Safety Recall

N252533322 Stabilizer Bar Bracket Fracture

Release Date: April 2026

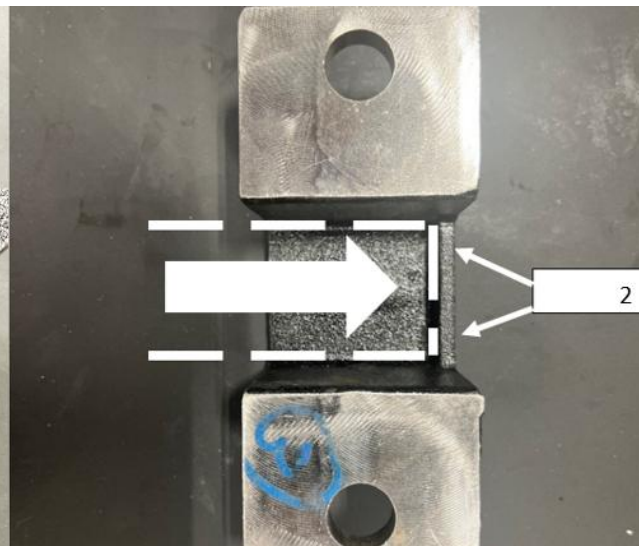
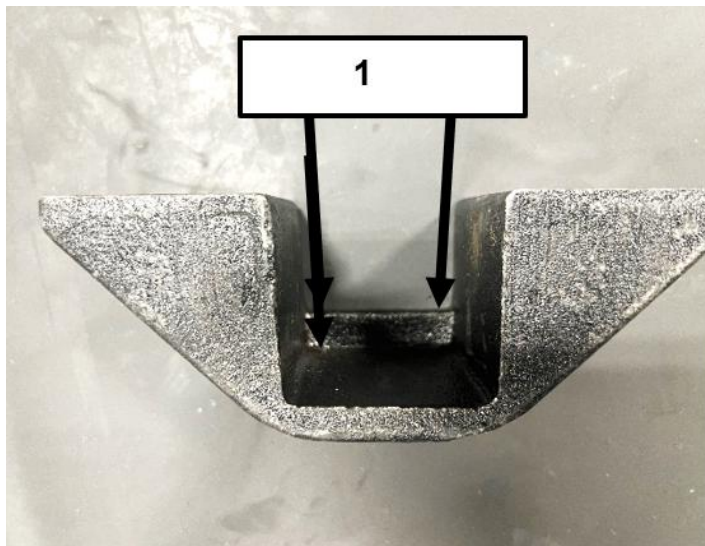
Condition	Isuzu Motors Limited has decided that a defect, which relates to motor vehicle safety, exists in certain 2018-2026 model year Chevrolet 6500 XD/7500 XD Low Cab Forward vehicles. In the affected vehicles, the front stabilizer bar brackets may break due to excessive stress on the stabilizer bar brackets and mounting studs, which may lead the front stabilizer bar to detach from the vehicle, creating a potential road hazard and risk to motor vehicle safety, including a risk of a crash.
Correction	Dealers will remove the old stabilizer bar brackets and replace them with new brackets.

2. Using a deep well socket, remove the two driver's side sway bar bracket nuts and washers (1) from the stabilizer bar bracket.
3. Remove the stabilizer bar bracket.

NOTE: The stabilizer bar should be aligned all the way over to the edge of the sway bar bracket (2).

4. Install a NEW stabilizer bar bracket onto the driver's side using the original washers and nuts.
5. Tighten the washers and nuts using a deep well socket and ratchet as tight as possible.
6. Perform steps 2-5 to replace the passenger's side stabilizer bar bracket.
7. Using a torque wrench, torque all four stabilizer bar bracket nuts to 170 Lb-ft (230 N-m).
